Plymouth South High School
Plymouth, MA
Ai3 Project # - 1308.00

Addendum #4

June 22, 2015

ADD4 SKL008

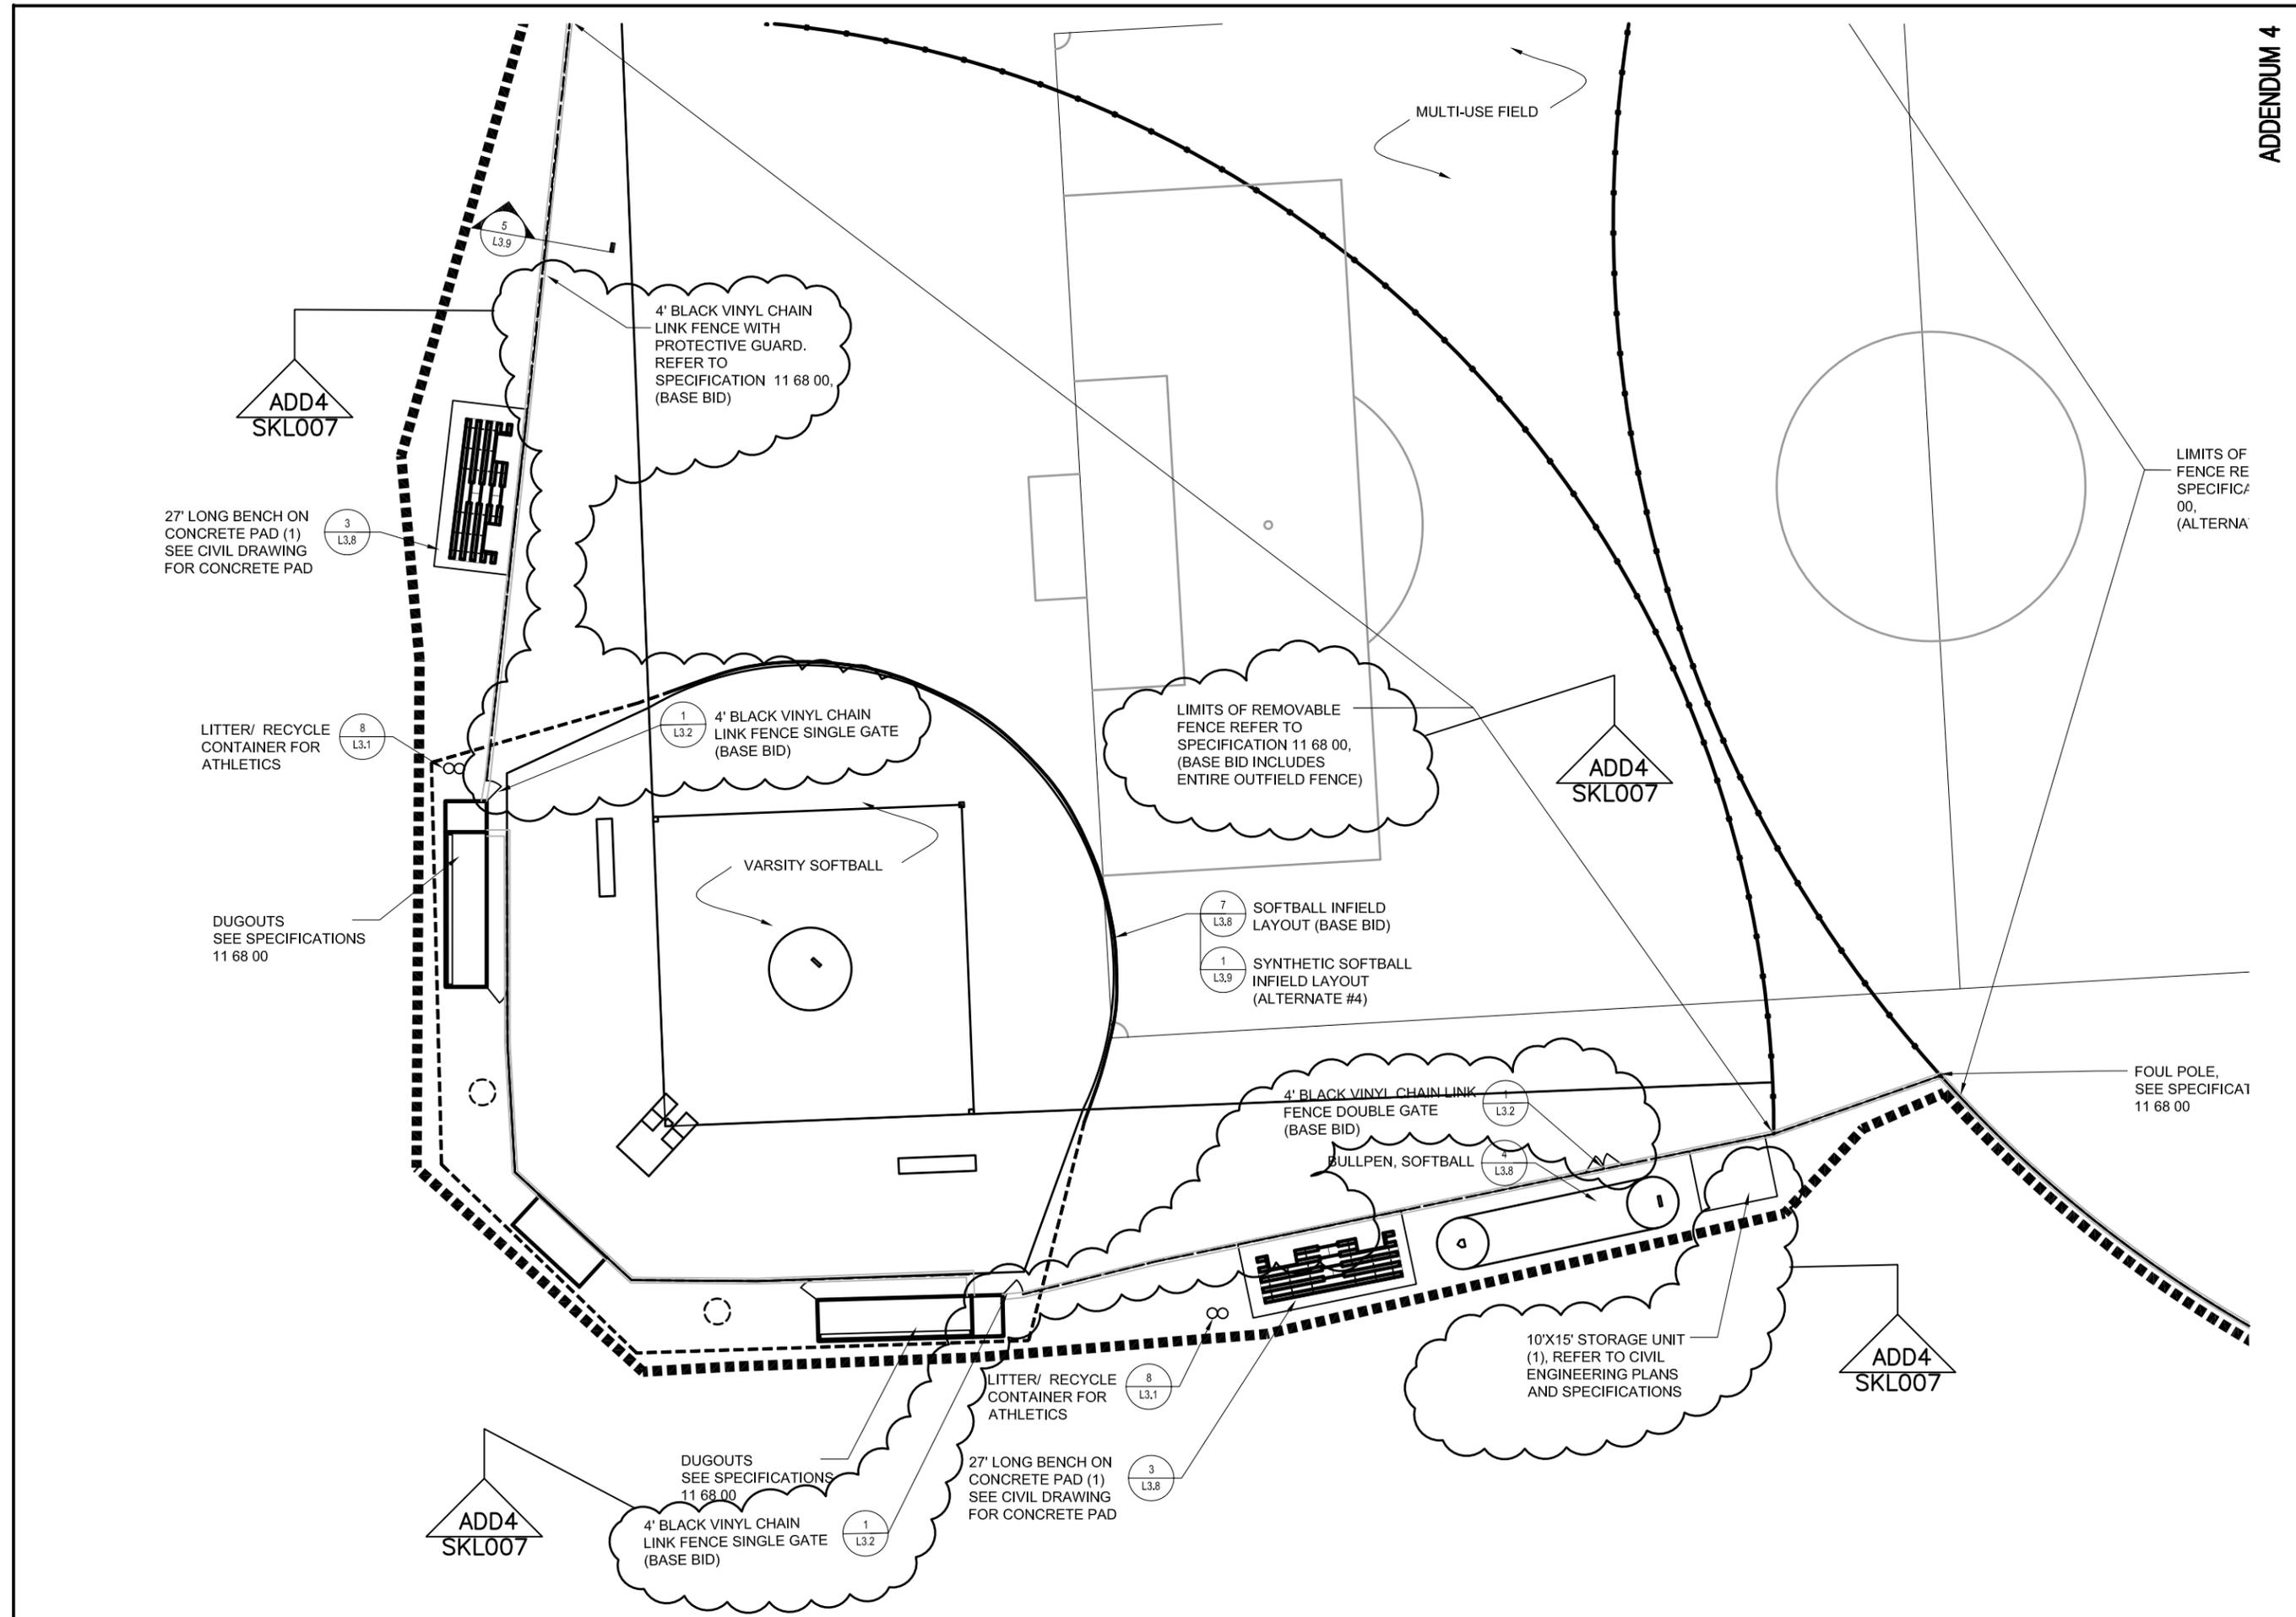
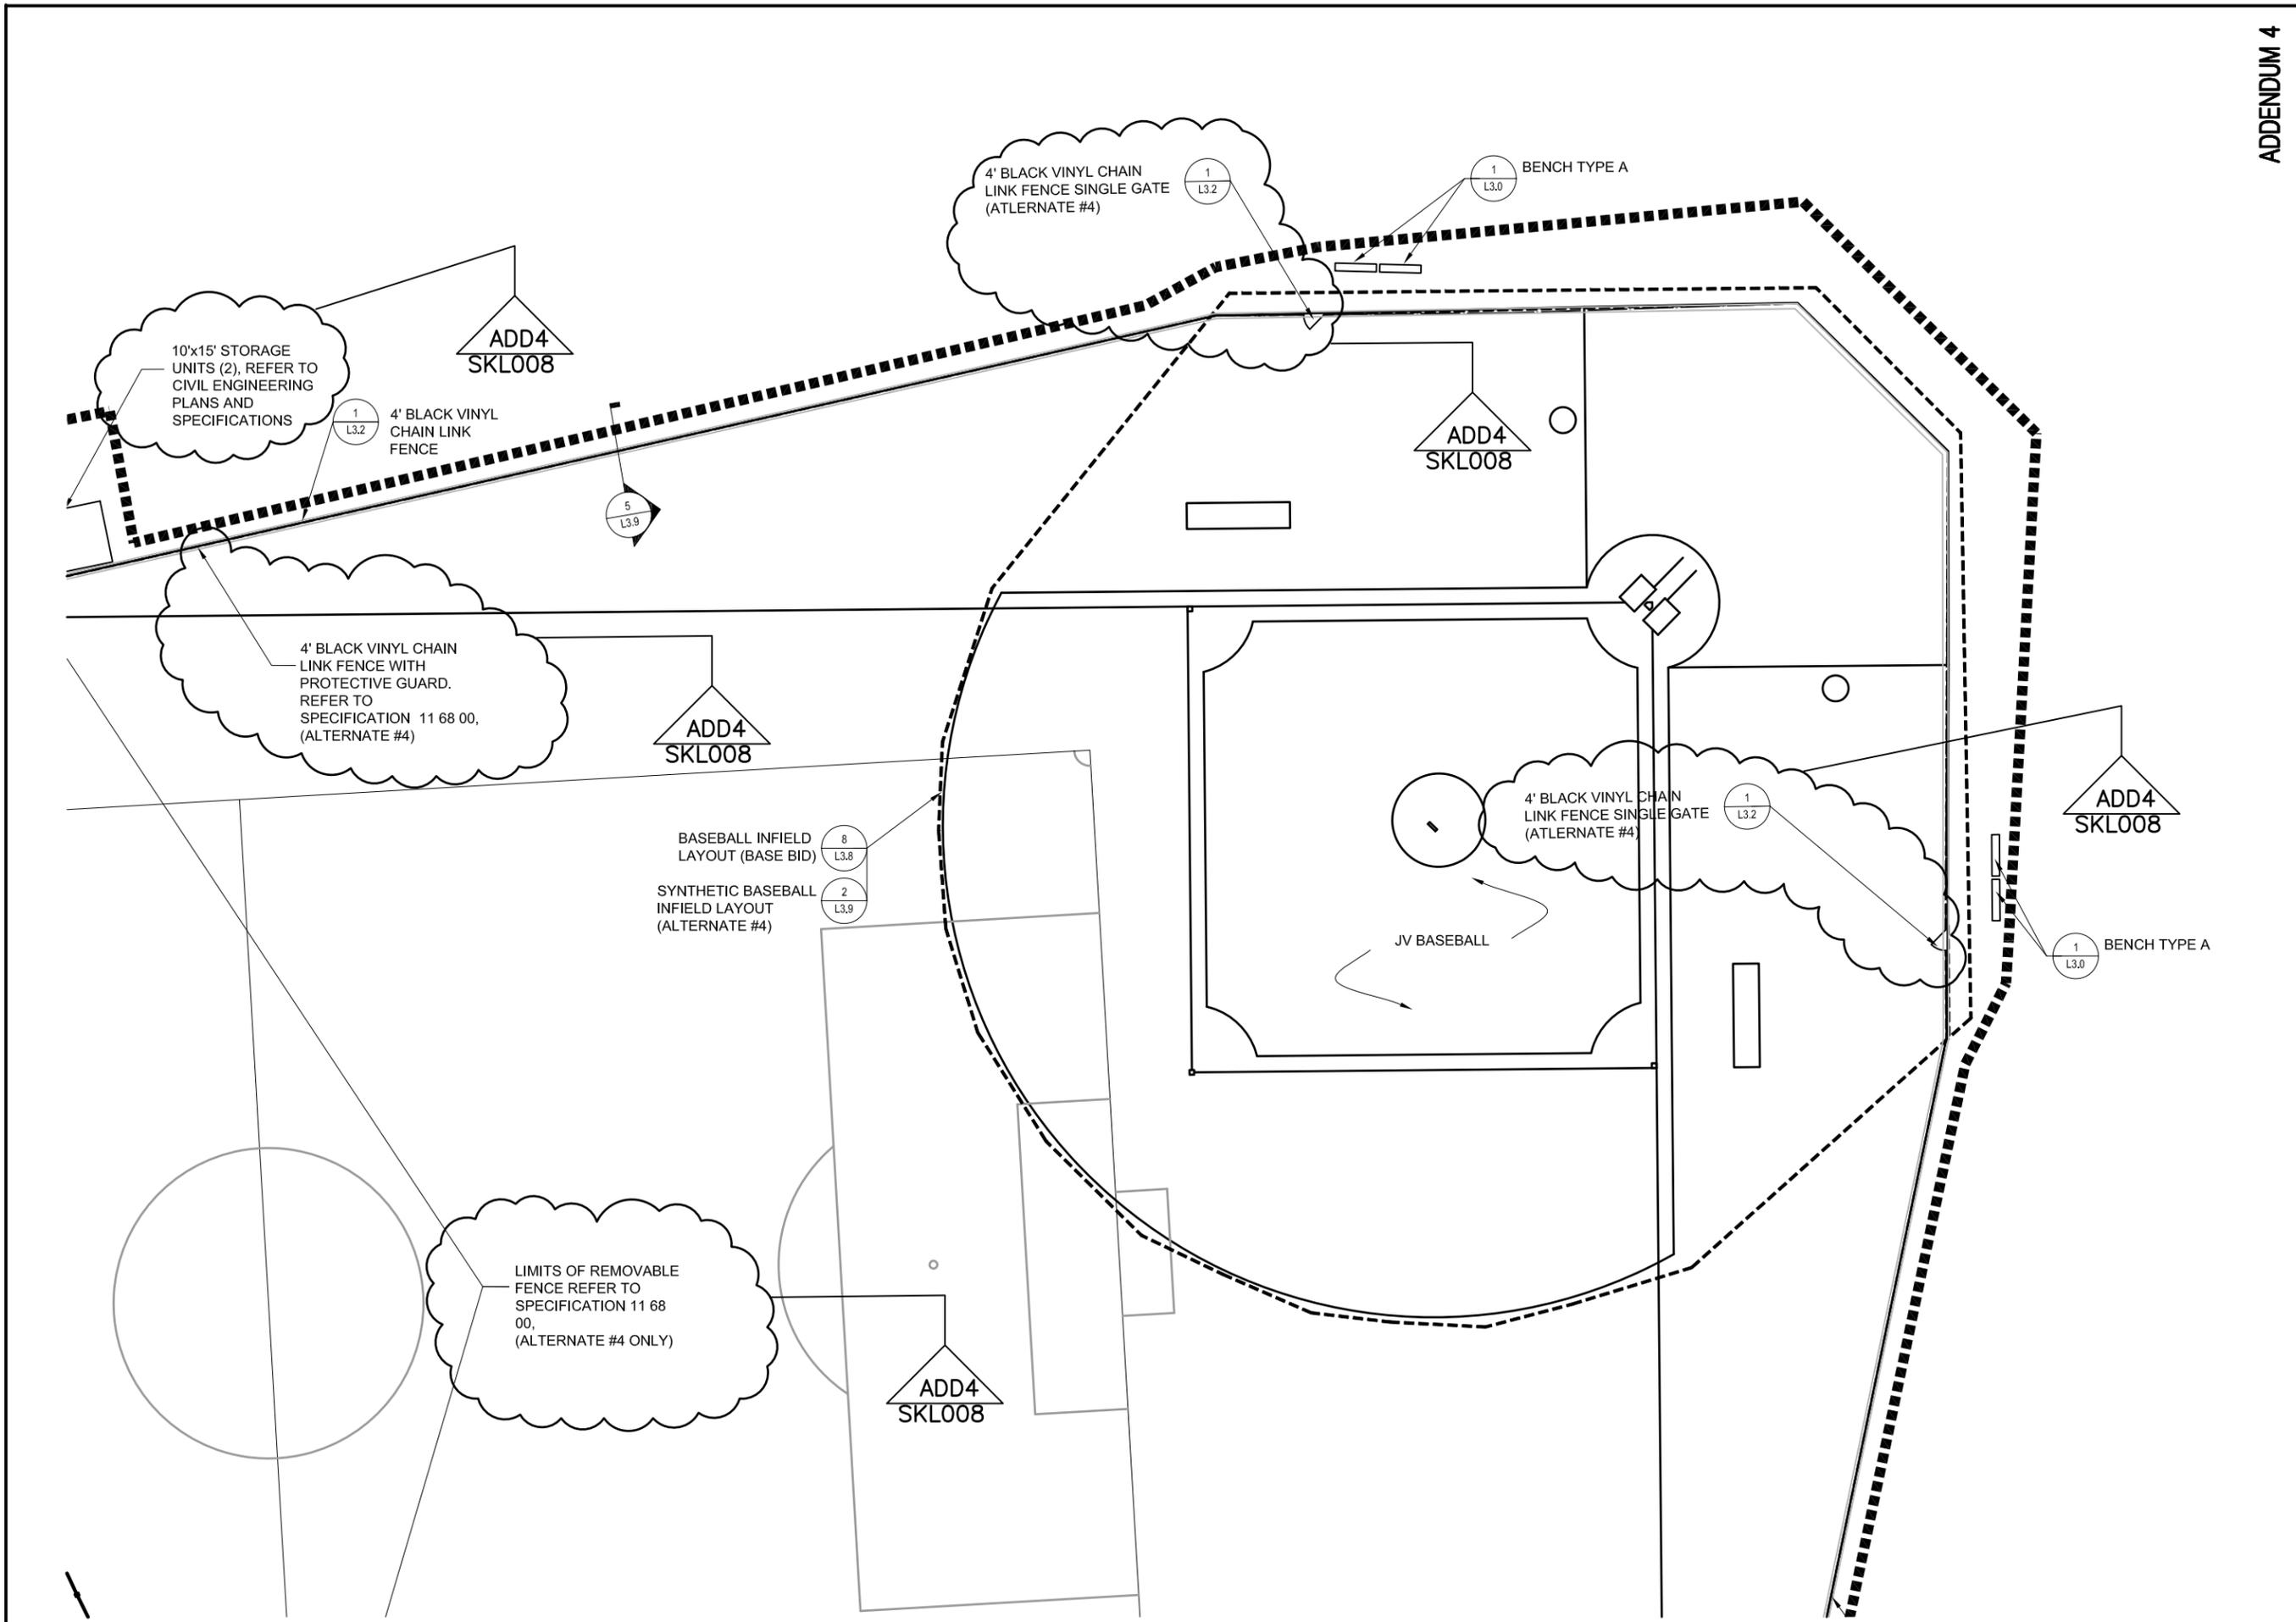
Detail 1 / Varsity Softball Field: Field C; REMOVE "11 69 00" and REPLACE with "11 68 00" on fence call out, per sketch SKL-007 and SKL-008.

REMOVE: "MOBIL ATHLETICS STORAGE UNIT (1) ON CONCRETE PAD SEE SPECIFICATIONS" and REPLACE with "12'x15' STORAGE UNIT (1), REFER TO CIVIL ENGINEERING PLANS AND SPECIFICATIONS" as indicated on SKL-007.

REMOVE: "MOBIL ATHLETICS STORAGE UNITS (2) ON CONCRETE PAD SEE SPECIFICATIONS" and REPLACE with "12'x15' STORAGE UNITS (2), REFER TO CIVIL ENGINEERING PLANS AND SPECIFICATIONS" as indicated on SKL-008.

REVISED all 4' black vinyl chain link fence with protective guard, 8' black vinyl chain link fence with protective guard, and 12' black vinyl chain link fence along the first base foul line and the third base foul line of the varsity softball field shall be part of the base bid as indicated on SKL-009.

REVISED all 8' black vinyl chain link fence with protective guard and 12' black vinyl chain link fence along the first base foul line and third base foul line of the JV baseball field shall be part of the base bid as indicated on SKL-009.
